Access Compliance Report

Public Rights-of-Way

(Curb Ramps)

Intersection ID: 50511	Main Street: ALLEN_A_BROWN_RD	Cross Street: MERIDALE_CROSSING_DR	Location: S
ADA ID: 951EB1C1AE53	Ramp Type: PerpDiag	Initial Pass/Fail: Fail	Overall Compliance: No
Severity Score: 10			
Codes/Mitigation Info/Possible Solution		Field Measurements/Component Compliance

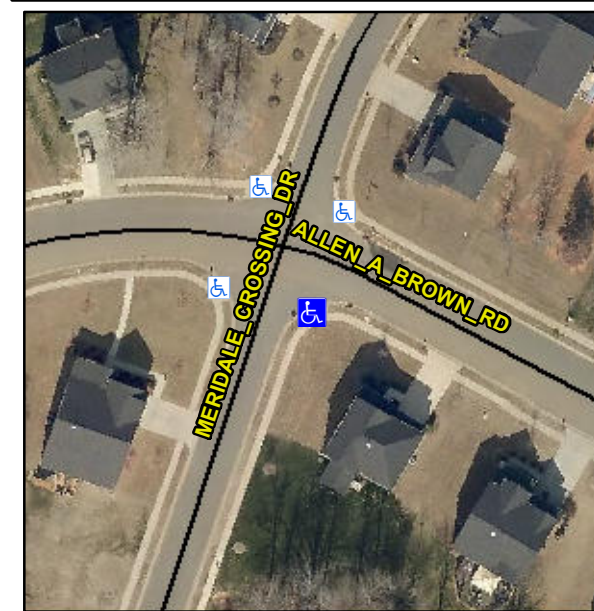
Not Found, R304.5.1, R304.5.3

Compliance	Description	Data	Compliance	Description	Data
N/A	Ramp Length (in)	48.0	Yes	Ramp Slope (%)	6.1
No	Ramp Width (in)	47.0	No	Ramp XSlope (%)	4.5
N/A	Flare Type LT	N/A	N/A	Flare Type RT	N/A
N/A	Flare Slope LT (%)	N/A	N/A	Flare Slope RT (%)	N/A
N/A	Flare Traversable LT?	N/A	N/A	Flare Traversable RT?	N/A
N/A	Landing Length (in)	N/A	N/A	DWS Provided?	N/A
N/A	Landing Width (in)	N/A	N/A	DWS Contrast?	N/A
N/A	Landing Slope (%)	N/A	N/A	DWS Length (in)	N/A
N/A	Landing X Slope (%)	N/A	N/A	DWS Full Width?	N/A
N/A	Landing Curb? (Y/N)	N/A	N/A	DWS Offset (in)	N/A
N/A	Shared Landing?	N/A			
N/A	Gutter Ponding?	N/A	N/A	Gutter Slope (%)	N/A
N/A	Gutter Lip Ht (in)	N/A	N/A	Gutter X Slope (%)	N/A
N/A	Painted X Walk1?	No	N/A	Painted X Walk2?	No
	X Walk 1 Direction	To NE		X Walk 2 Direction	To NW
N/A	X Walk 1 Width (in)	N/A	N/A	X Walk 2 Width (in)	N/A
	X Walk 1 Slope (%)	3.6		X Walk 2 Slope (%)	2.8
	X Walk 1 X Slope (%)	0.7		X Walk 2 X Slope (%)	3.9

Remove & Replace Curb Ramp With Two New Directional Ramps or Equivalent.
